SUBJECT: Application to amend Tech Specs App a to License DPR-49.  
 Amend is for reactor startup & operation greater than  
 24-h w/one recirculation loop out of svc.Class III license  
 change fee encl.

May 2, 1980  
LDR-80-127

Proposed Change RTS 119 to  
The Duane Arnold Energy Center  
Technical Specifications

FIGURE 1. MAIN TURBINE TRIP WITH BYPASS MANUAL FLOW CONTROL

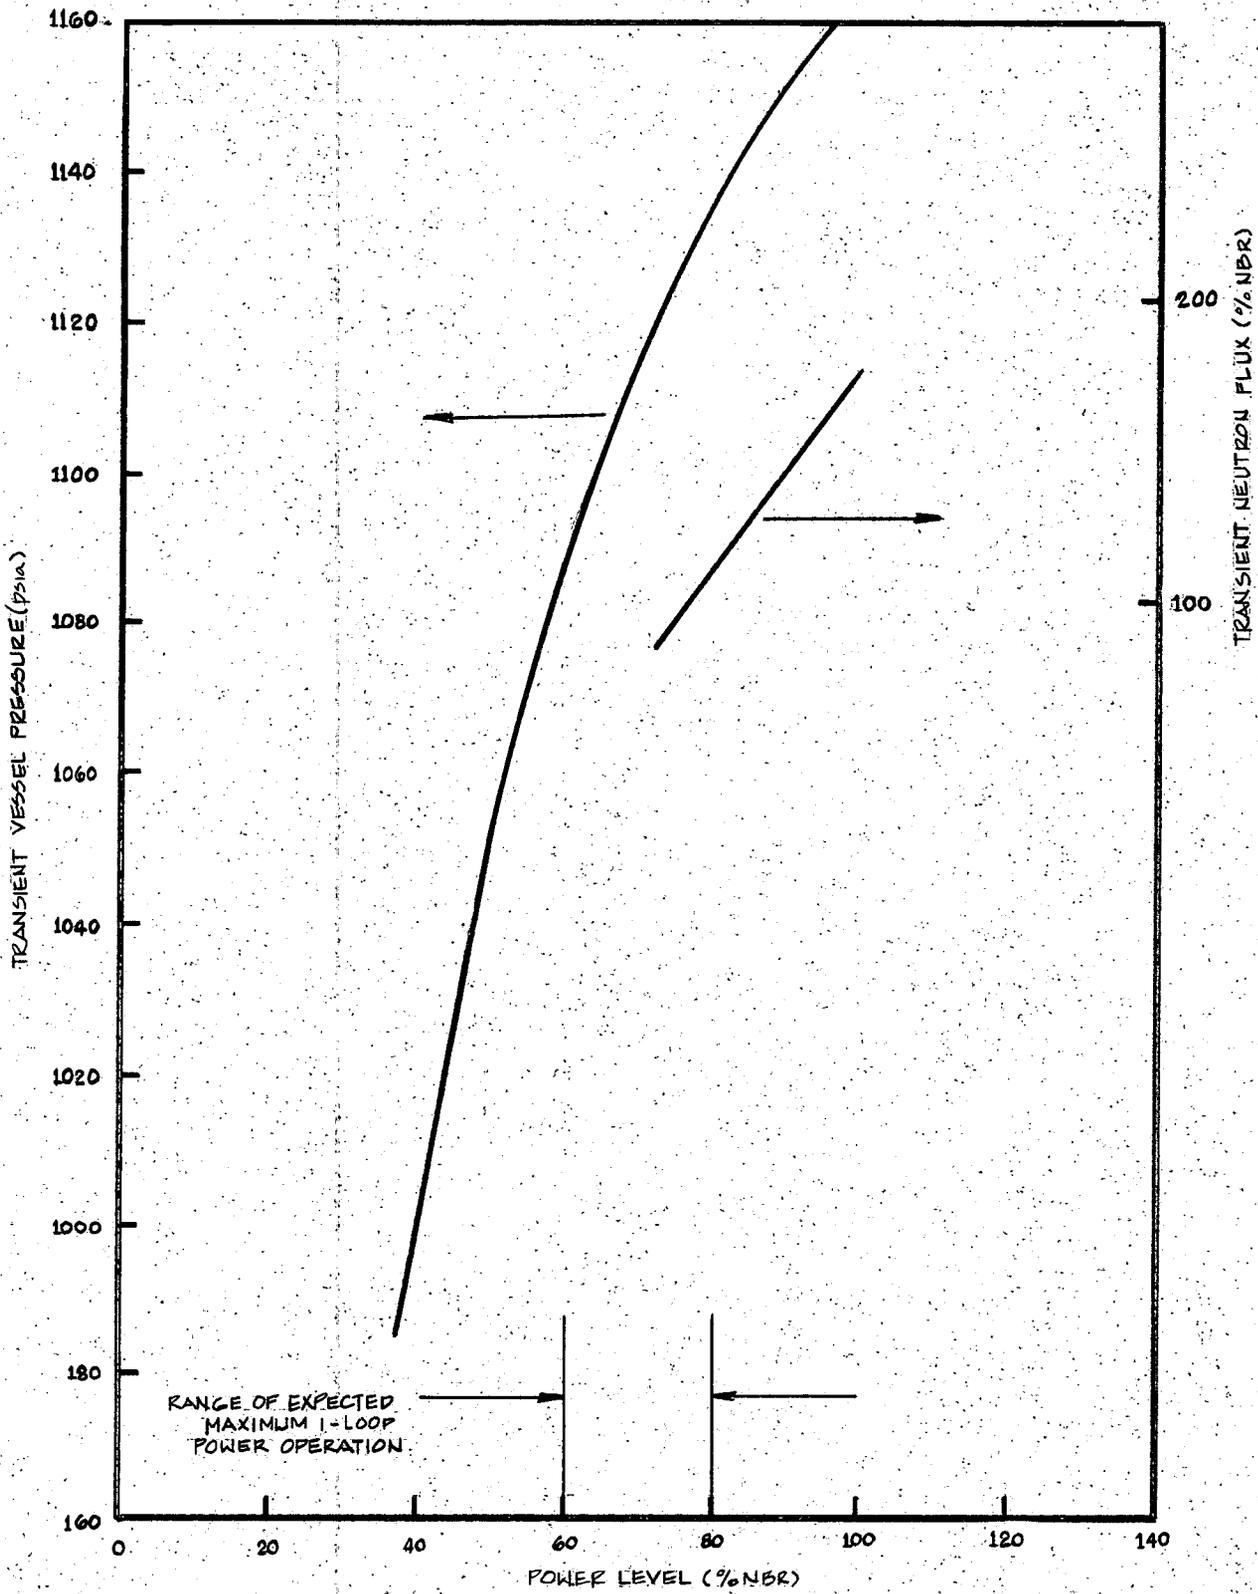
For pressurization, flow decrease, and cold water increase, transients previously transmitted for Reload/FSAR results bound both the thermal and overpressure consequences of one-loop operation. Figure 1 shows the consequences of a typical pressurization transient (turbine trip) as a function of power level. As can be seen, the consequences of one-loop operation are considerably less because of the associated reduction in operating power level.

FIGURE 2. CORE FLOW VERSUS DRIVE FLOW FOR ONE-AND-TWO-PUMP OPERATION

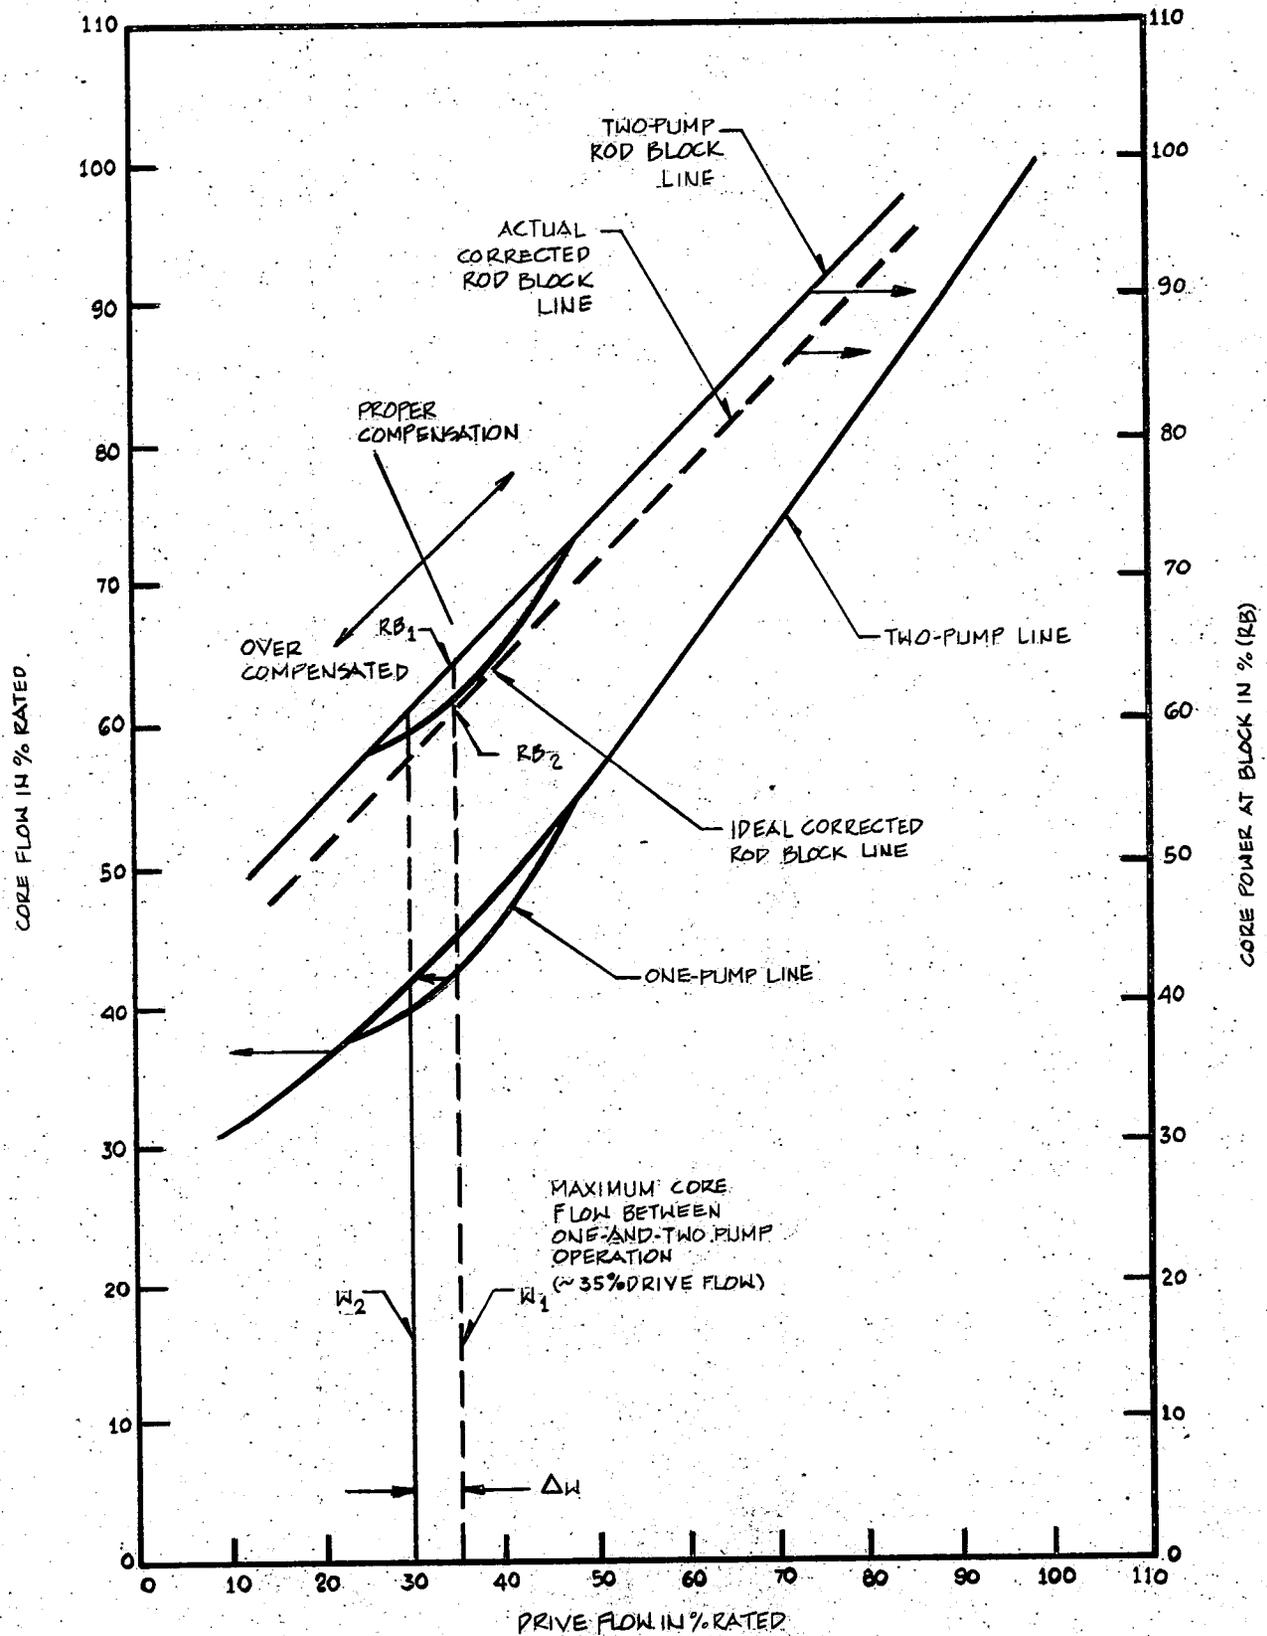
Both the active and inactive flows are derived from the jet pump differential pressures. The drive flow is derived from the differential pressure measurement in the active recirculation loop. These two curves are plotted from a BWR data in Figure 2. The maximum difference between the one-pump and two-pump core flow is determined graphically. This occurs at about 35% drive flow which is denoted  $W$ .

- c. Next, a horizontal line is drawn from the 35% drive flow point on the one pump curve to the two pump curve and the corresponding flow,  $W_2$ , is determined. Thus,  $\Delta W = W_1 - W_2$ .

From Figure 2:

$$\Delta W = W_1 - W_2 = 35 - 30 = 5$$

$$RB = 0.66W + 108 - 0.66(100+5) = 0.66W + 38.7 \quad (4)$$

This line is depicted in Figure 2 as the future corrected rod block line for one-pump operation.

$$S \leq (0.66W + 38.7) \frac{FRP}{MFLPD} \text{ for one recirculation loop operation.}$$

FIGURE 3. DECAY RATIO VERSUS POWER CURVE FOR TWO-LOOP AND SINGLE-LOOP OPERATION

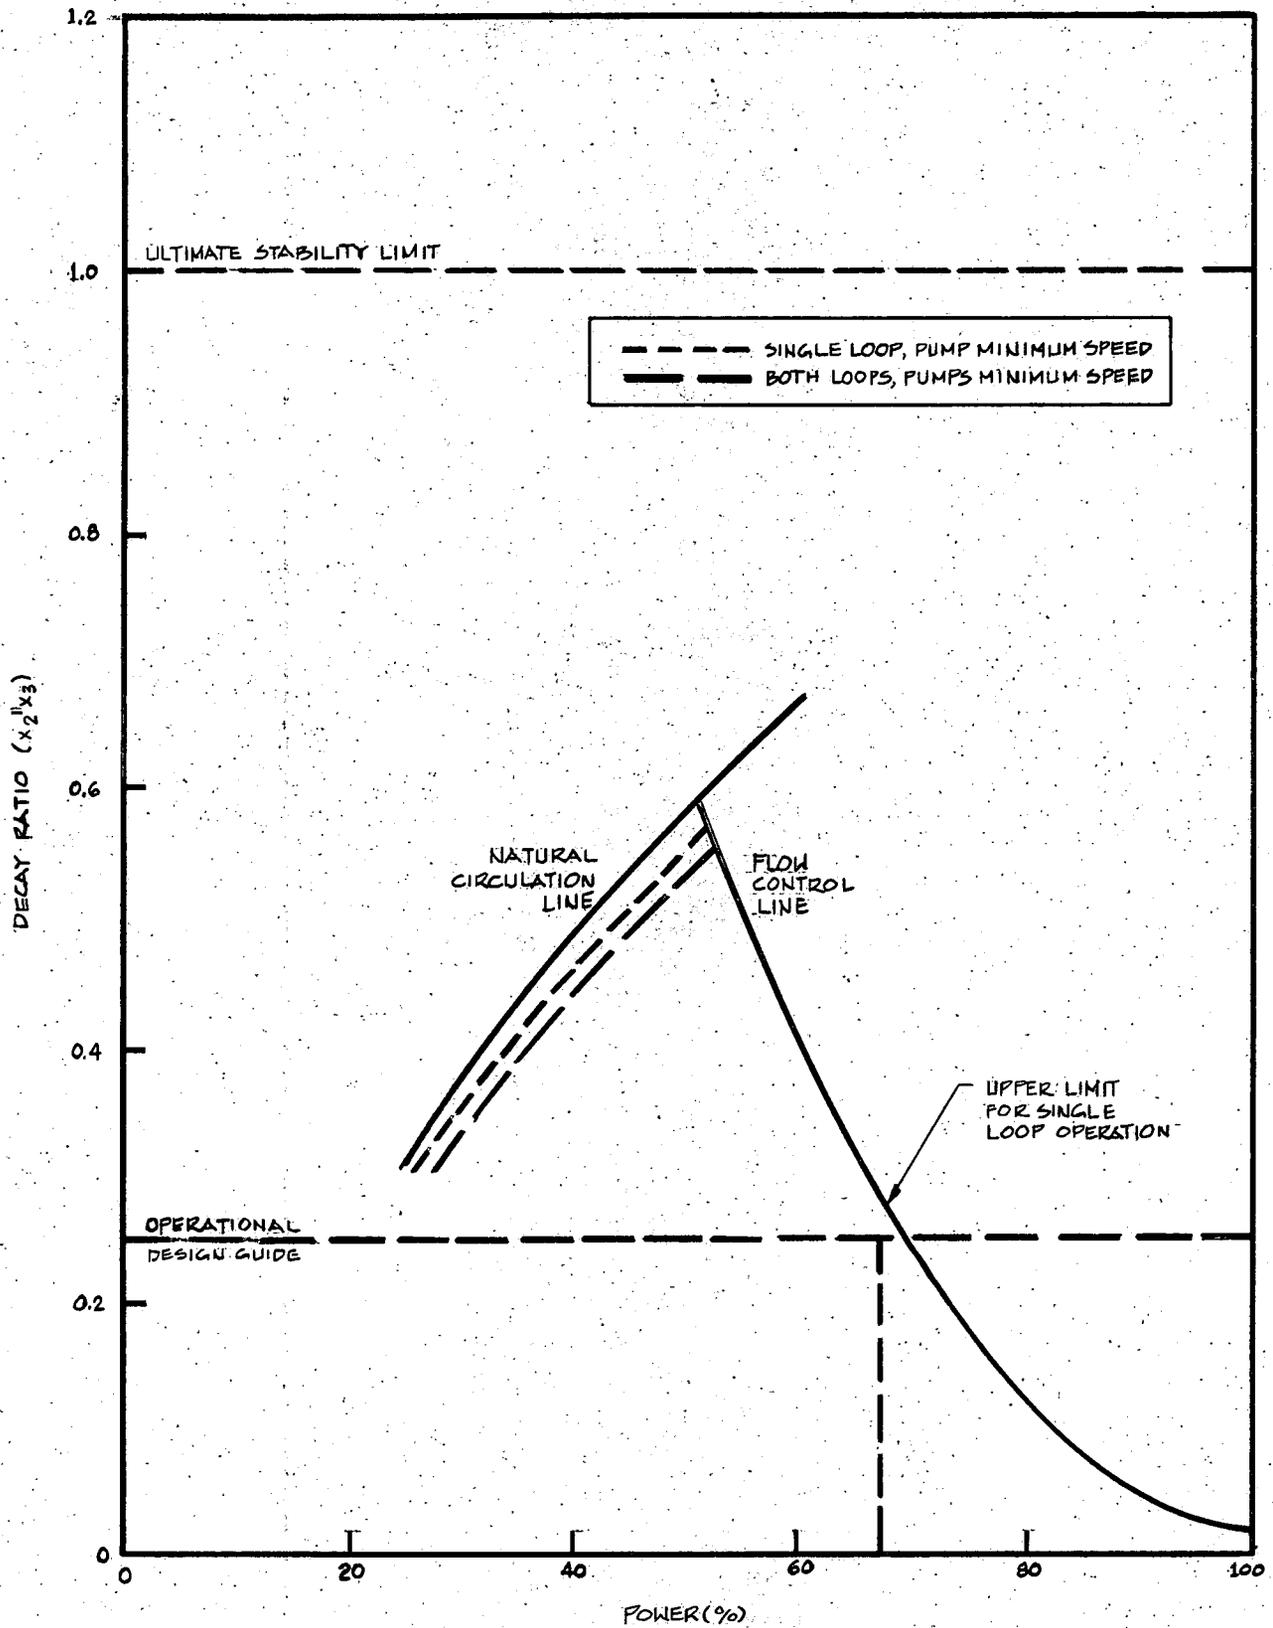
The least stable power/flow condition attainable under normal conditions occurs at natural circulation with the control rods set for rated power and flow. This condition may be reached following the trip of both recirculation pumps. Operation along the minimum forced recirculation line with one pump running at minimum speed is more stable than operating with natural circulation flow only, but is less stable than operating with both pumps operating at minimum speed. The core stability along the forced circulation, rated rod pattern line for single loop operation is the same as that for both loops operable except that rated power is not attainable. Hence, the core is limited to maximum power for single pump operation and only manual flow control should be used. This is illustrated in Figure 3.
